**ADDENDUM #1**

**TO: ALL PLAN HOLDERS AND POTENTIAL BIDDERS**  
**FROM: Ron Venturella, PURCHASING OFFICER** *RV*  
**SUBJECT: 13-AC REYNOLDS HIGH MINITORIUM WALL PANEL REPLACEMENT (RPF 30-12)**

**Addendum # 1**  
**Pre-Bid Meeting Minutes & Addendum # 1**

Addendum #1: ACRHS  
Minitorium Wall Panels

**WALL/SILL DETAIL**

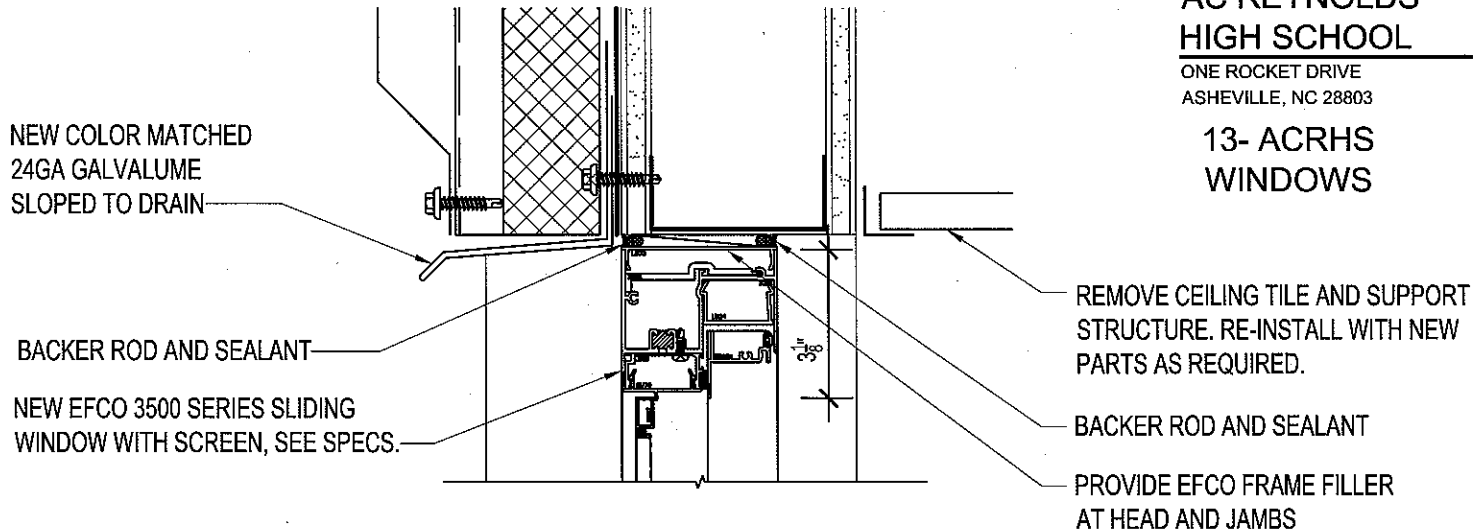
10. General contractor is responsible for obtaining all required jurisdictional permits within the Base Bid.
11. Detail 1/SK-4: It was noted that the actual field conditions for the existing height of flashings varies.

**1 WALL/HEAD/ROOF DETAIL**  
3" = 1'-0"

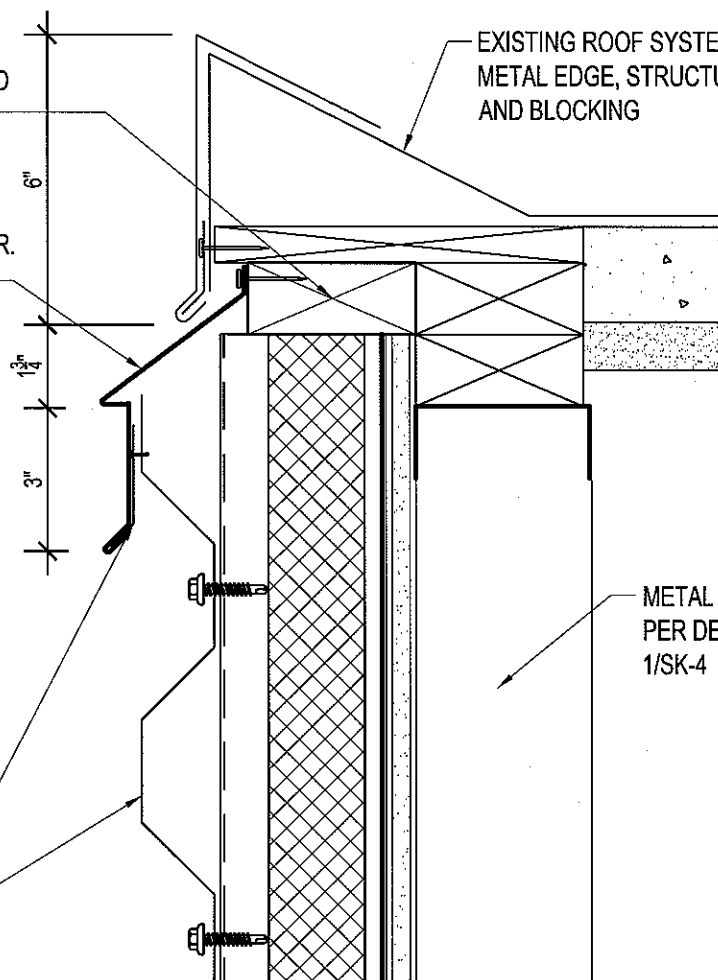
12. Detail 1/SK-6: Verify Nailer Condition: Contractor is to provide a minimum of (2) 2 x 6 Fire Retardant Treated nailers bolted to the bar joists in the bid.

VERIFY NAILER CONDITION:  
NEW ACQ 2 X 4 KDAT NAILER  
FASTENED WITH STAINLESS  
STEEL SCREWS PRE-DRILLED  
AT 24" O.C.
